# Access Compliance Report

## Public Rights-of-Way

### (Pedestrian Signals)

Intersection ID: N/A	Main Street:	Cross Street: N/A	Location: N/A
ADA ID: 3FA292EC0506	Signal Type: One Push Button-Non APS	Overall Compliance: No	Severity Score: BTN 1: N/A BTN 2: N/A No BTN: N/A
Codes/Mitigation Info/Possible Solution		Field Measurements/Component Compliance

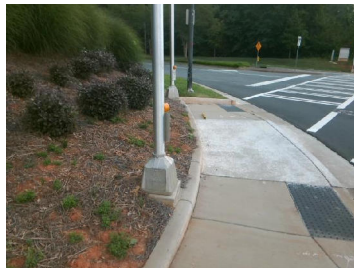
Surveyor Notes: TEXT HT 1/2, BUTTON DOES NOT WORK WHEN PRESSED

PROW/ADA: TMUTCD 4e.08, R410.6, R404.2, R406.2, R403.4

Possible Solutions: Replace Signal Push Button With APS Button on New Post. Remove & Replace Sign.
